DATE:	October 20, 2026
TO:	Nolensville Planning Commission
FROM:	Adam Ray, Town Planner Brad Baumgartner, Planning Director
SUBJECT:	Hillside Center Phase 2 Site Plan Revision #2
APPLICANT/ COMPANY:	Mohsen Malakouti / M & S Holdings
OWNER/ COMPANY:	Mohsen Malakouti / M & S Holdings
DESCRIPTION:	Approximately 2.61 acres of a 10.11-acre parcel located on Map 56, Parcel 05500

Upper Floor Parking Spaces	72	82
Total Upper Floor Parking Spaces	**102**	**115**

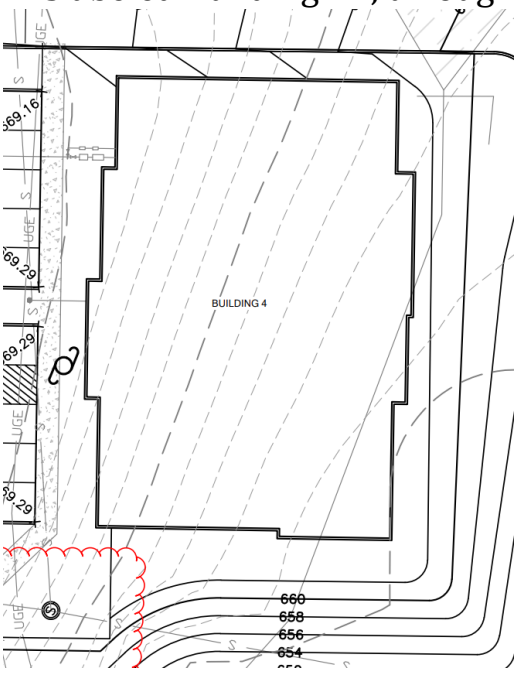
1. The Applicant shall revise the incorrect parking total for proposed Building #5 and already constructed Building #6 (Regus) in the Site Data Table from 82 to 77. Seventy-seven is the correct amount constructed and proposed in the plan set drawings. The Applicant shall also update the title of that section block, to not include Building #4, since this building was merged with newly proposed Building #5.
